Product Change Notice (PCN)

Subject: Transfer of back-end production for general-purpose linear IC products (SOP package products)
Publication Date: 1/19/2024
Effective Date: 5/13/2024

SOP-14 :

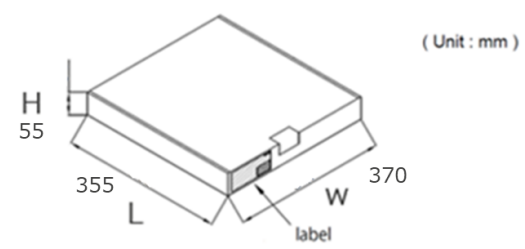
There are some dimensional differences in the outline drawing, but the recommended foot pattern remains the same.

Current products		UTL products	
(UNIT:mm)		(UNIT:mm)	
ITEM	MILLIMETERS	ITEM	DIMENSIONS
A	10.2 ±0.26	A	10.2±0.2
B	1.42 MAX	B	1.42MAX
C	1.27 (T.P)	C	1.27(T.P)
D	0.42 ^{+0.08} _{-0.07}	D	0.40±0.05
E	0.1 ±0.1	E	0.1±0.1
F	1.59 ^{+0.21} _{-0.2}	F	1.59±0.20
G	1.49	G	1.49
H	6.5 ±0.2	H	6.5±0.2
I	4.4 ±0.1	I	4.4±0.1
J	1.1 ±0.16	J	1.05±0.15
K	0.17 ^{+0.08} _{-0.07}	K	0.2±0.07
L	0.6 ±0.2	L	0.6±0.20
M	0.1	M	0.1MAX
N	0.10	N	0.1MAX
P	3° ^{+7°} _{-3°}	P	4°±4°

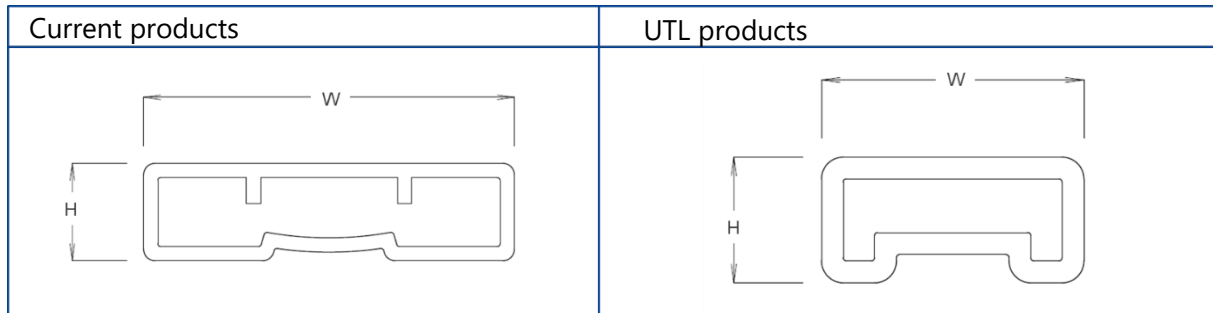
The size of the tube is different as follows.

PKG	Current products (L×W×H), Quantity	UTL products (L×W×H), Quantity
SOP-8	530×13×3.4 (mm), Max100pcs	507~509×8.4×4.0 (mm) , Max90pcs
SOP-14	530×13×3.4 (mm), Max50pcs	507~509×8.4×4.0 (mm) , Max45pcs

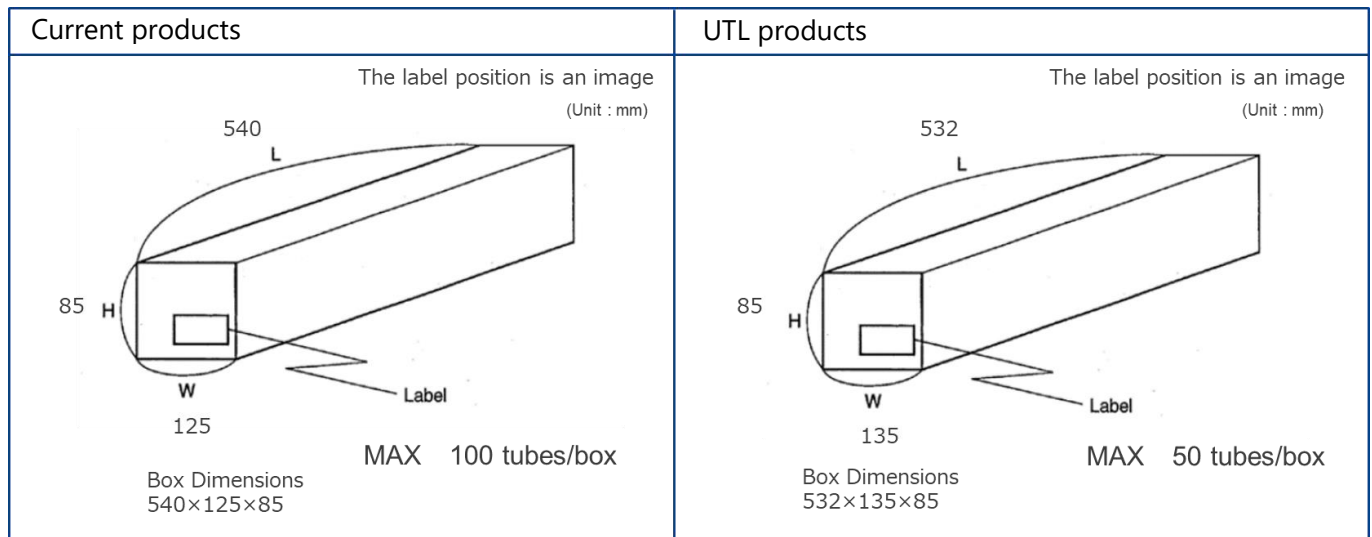
The packaging box size of the tube product is different as follows.

Current products (L×W×H)	UTL products (L×W×H)
540×125×85 (mm)	532×135×85 (mm)
